DRAFT REMEDIAL INVESTIGATION REPORT, IR SITE 27, DOCK ZONE, ALAMEDA POINT, ALAMEDA, CALIFORNIA

SUBJECT: REVIEW OF THE DRAFT REMEDIAL INVESTIGATION REPORT, IR SITE 27, DOCK ZONE, ALAMEDA POINT, ALAMEDA, CALIFORNIA DATED MARCH 2005

SUBJECT: NAVAL AIR STATION ALAMEDA (ALAMEDA POINT) IR SITE 27,
DOCK ZONE DRAFT REMEDIAL INVESTIGATION REPORT
[SITE 201209-18 PCA 18040 H:48]

Figure A-1. Runoff vs. rainfall.

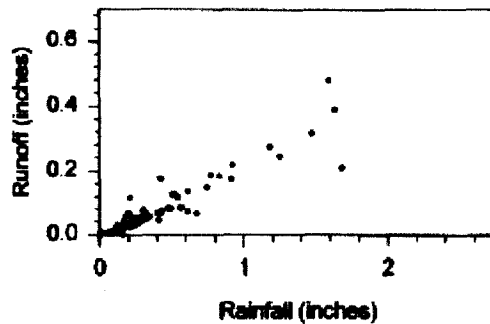
14. Water filtration is not considered a primary current transport pathway (Section 5.2.4, page 5-5). While pavement may inhibit and reduce infiltration of rainfall or irrigation water, up to 80 percent of rainfall can infiltrate through pavement and landscaping in residential watersheds (Attachment A). The point of presenting this material is to indicate that infiltration may be a more significant transport mechanism for soil contaminants to shallow groundwater than stated. An assessment should always be made of common geographical patterns of soil contamination and groundwater contamination, especially in areas with shallow groundwater such as NAS Alameda.
